January 13, 2026

**RE: Proposed Modification to the Gas Monitoring System Plan (GMSP)
Iowa County Sanitary Landfill - 48-SDP-02-79P**

FIGURE:		2
REVISION	NO.	DATE
DRAWN DRA	PROJECT NO. 6005	DATE 1-9-26

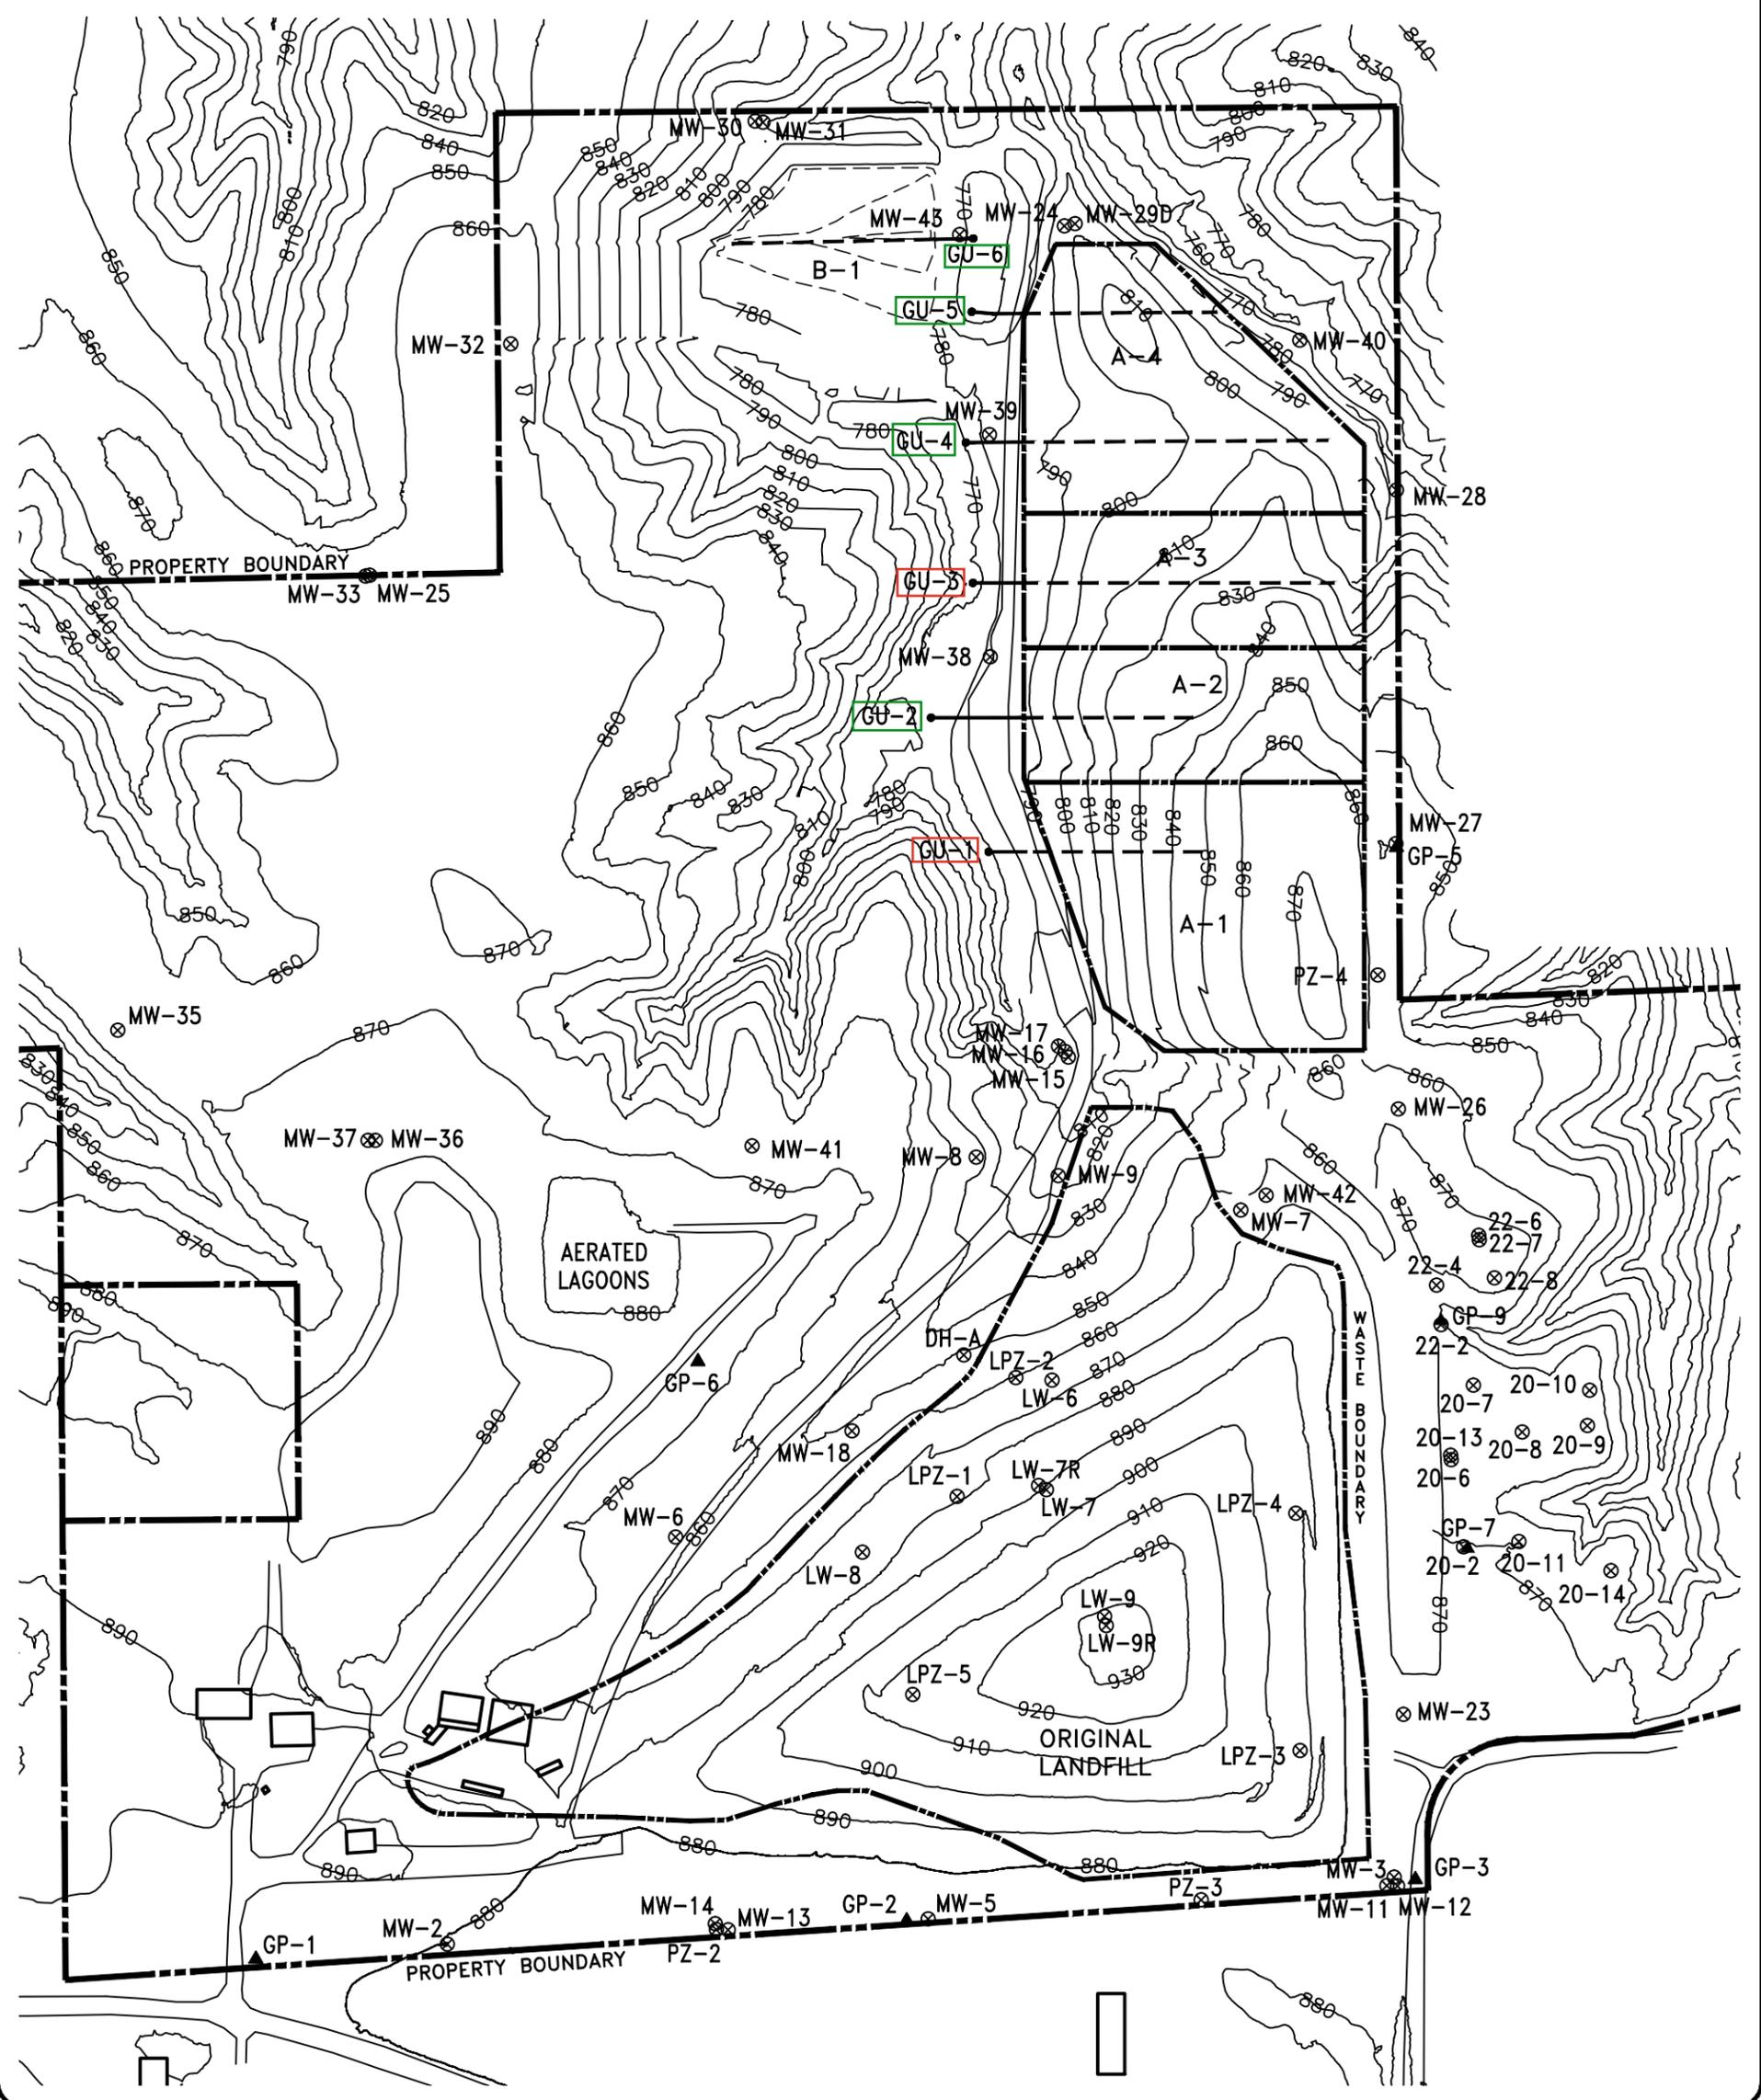
Review of the Site Plan (Figure 2, attached) illustrates the location of UD-1 through UD-6 (GU-1 through GU-6). All underdrain discharge points are in the central portion of the site, not near a property line.

We request that UD-1 and UD-3 (also known as GU-1 and GU-3, respectively) be removed from the GMSP. We anticipate that the remaining and functioning underdrain pipes UD-2, UD-4, UD-5, and UD-6 (GU-2, GU-4, GU-5, and GU-6, respectively) will remain in the GMSP and are sufficient in number to monitor gas concentrations in the interior portion of the site.
